**TOWN OF MOUNTAIN VILLAGE
REGULAR DESIGN REVIEW BOARD MEETING AGENDA
THURSDAY SEPTEMBER 7, 2023, 10:00 AM
MOUNTAIN VILLAGE TOWN HALL
455 MOUNTAIN VILLAGE BLVD, MOUNTAIN VILLAGE, COLORADO
TO BE HELD HYBRID THROUGH ZOOM:
<https://us06web.zoom.us/j/81245118996>
Meeting ID: 812 4511 8996**

**DESIGN REVIEW BOARD MINUTES
TOWN OF MOUNTAIN VILLAGE
REGULAR DESIGN REVIEW BOARD MEETING
SEPTEMBER 7, 2023**

AGENDA ITEM 8
PLANNING & DEVELOPMENT SERVICE
PLANNING DIVISION
455 Mountain Village Blvd.
Mountain Village, CO 81435
(970) 728-1392

LIGHTING NOTES:

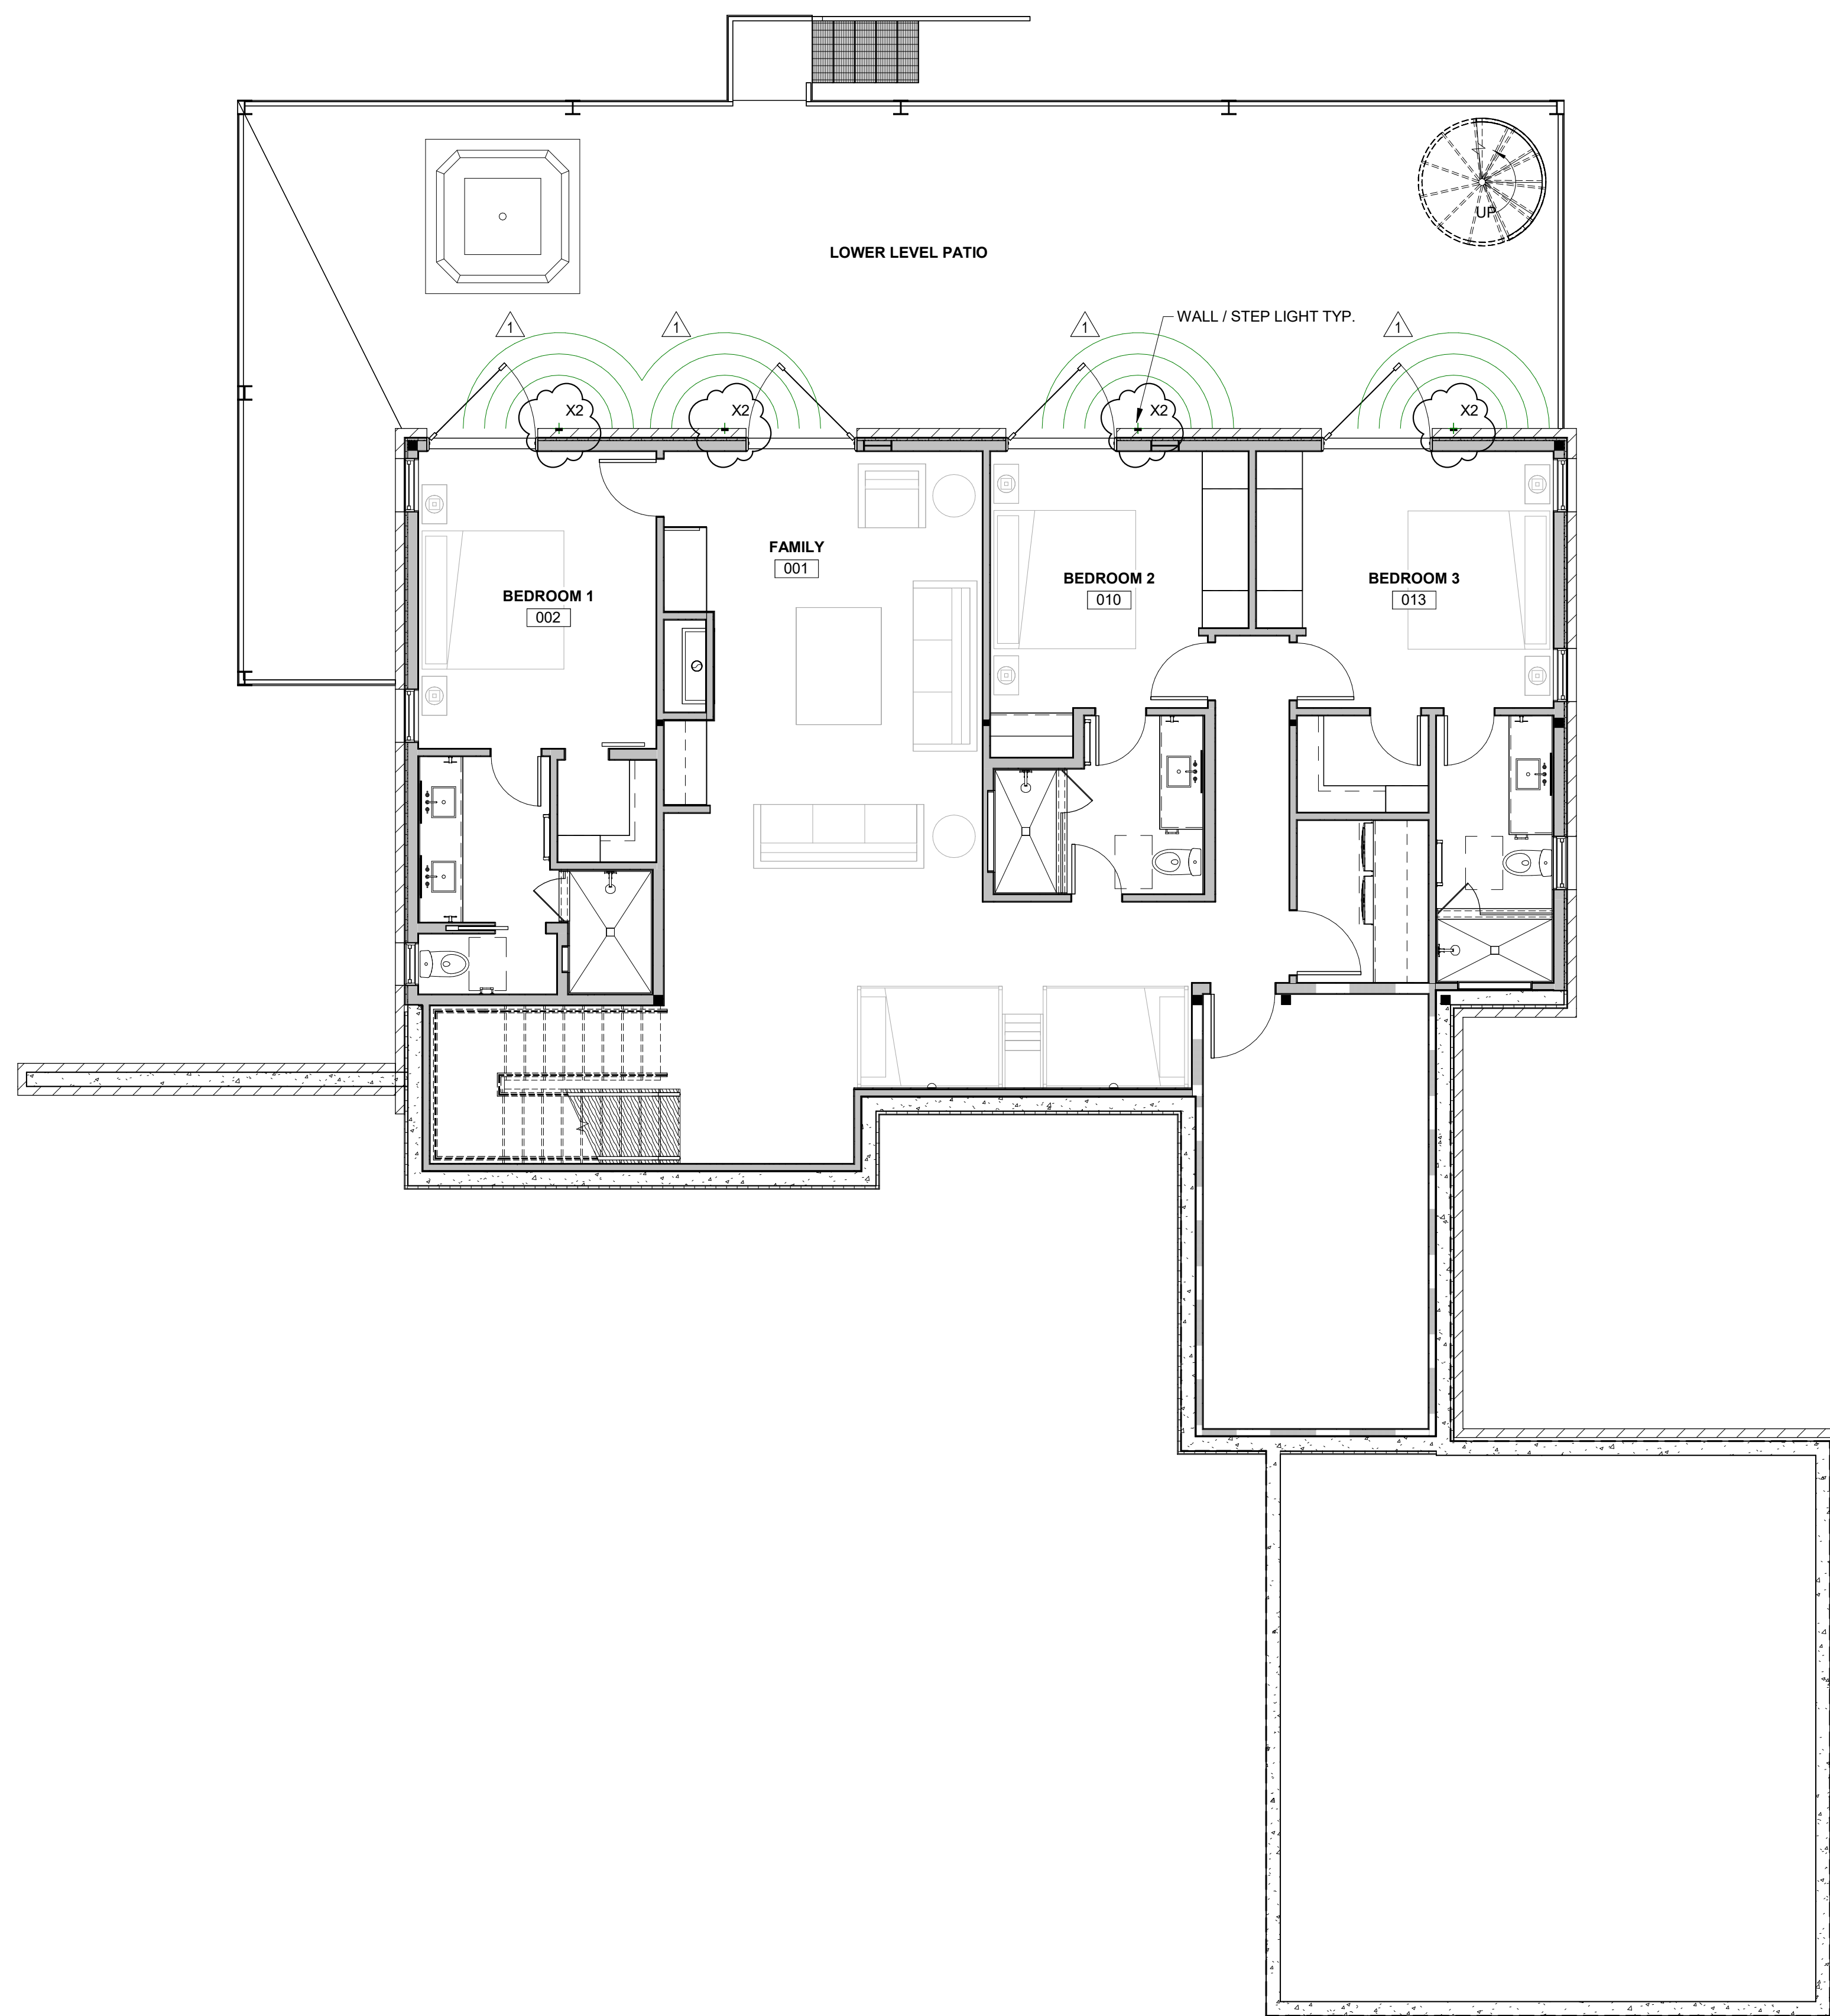
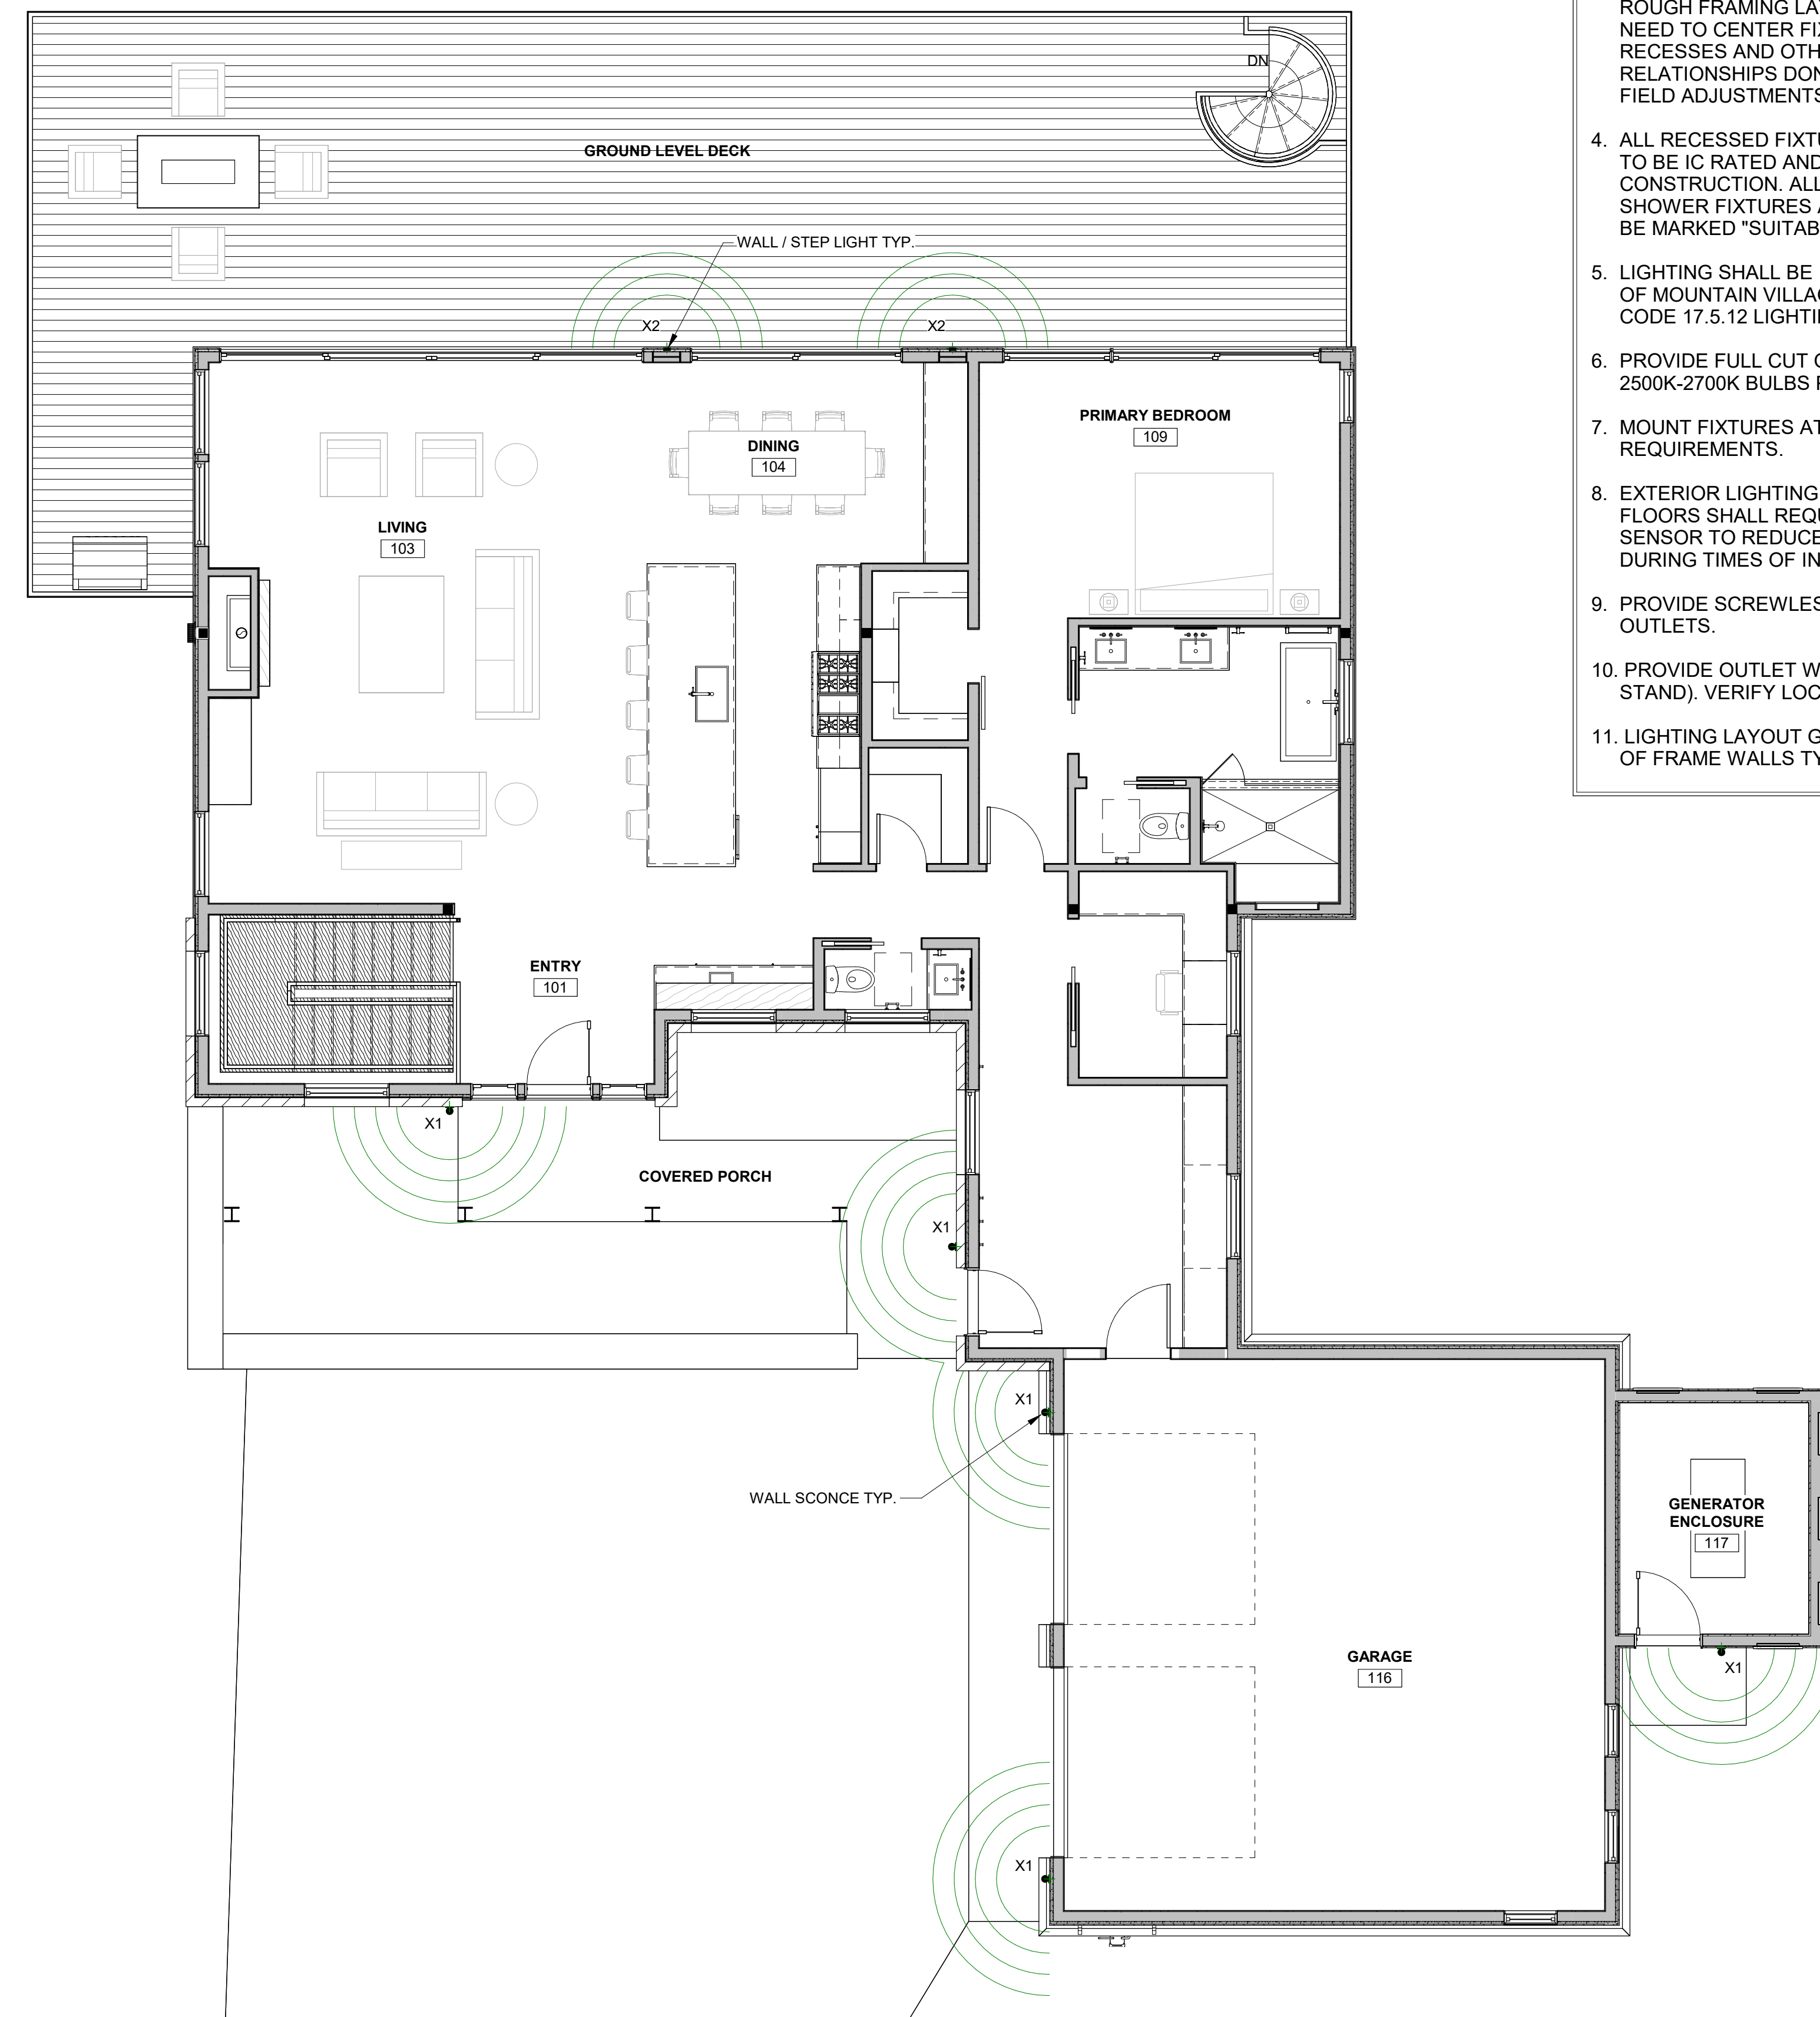
The applicant has provided a lighting plan with spec sheets on Sheet LTG1.1 in Exhibit A. The basic guideline for exterior lighting is for it to be subdued, understated and indirect to
